Response to Closeout for iTPC Technical Cost, Schedule, and Risk Review

Prepared by: Z. Xu, F. Videbaek, L. Ruan, B. Scheetz, T. Ljubicic, I. Chakaberia, Y. Fisyak, R. Sharma, R. Pak, W. Christie, P. Sorensen (BNL), D. Cebra (UC Davis), D. Keane (Kent State), G. Odyniec, N. Xu, and J. Thomas (LBNL), and B. Mohanty (NISER)

The review committee has requested a document describing the physics impact of running in RHIC FY19 with a shorter run or previous generation of electronics mounted on new iTPC sectors.

Figure 2: Layout of the padplane with the new option. Each colored area indicates the pads belonging to a given connector. Each connector connects up to 32 even and 32 odd pads from even and odd rows.

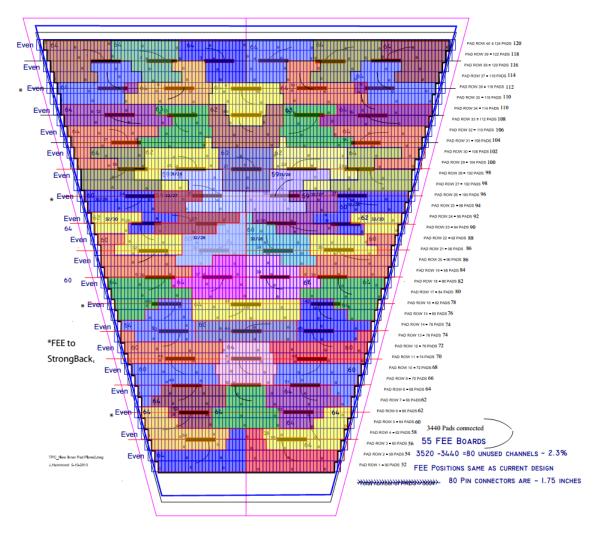
We are responding to the iTPC Reviewers' comment regarding the backup mitigation option of the readout of every 2nd pad row of the new iTPC 40-row pad plane using STAR TPC's old electronics in case the SAMPA chip schedule slips.

We agree with the Reviewers' suggestion that we should prove to ourselves that this option is physically possible. We decided that the simplest path is to re-do the current mapping of the pads ⇔ connectors/pins map to make absolutely sure that this scheme will work. We proceeded with this plan and we have completed the new mapping. The new scheme guarantees (up to) 32 pads from even or odd pad rows for *every* connector on the pad plane. While certain board traces are now slightly longer, we don't think this will make an appreciable difference to the capacitive noise.

Once we decided to embark on this effort, we also took the opportunity to make the maps such that we only need one adaptor type (instead of potentially 55). To make this as simple as possible, we assigned odd pad rows to one side of the connector and even pad rows to the other. We can now either use an "odd" adaptor type that will pick up only odd rows, or we can use the "even" adaptor type that will only pick up even rows. This decision is relatively unimportant so it will be made at a later time. These are very simple passive adaptors which bridge one connector type to another so they don't represent a major engineering or cost item.
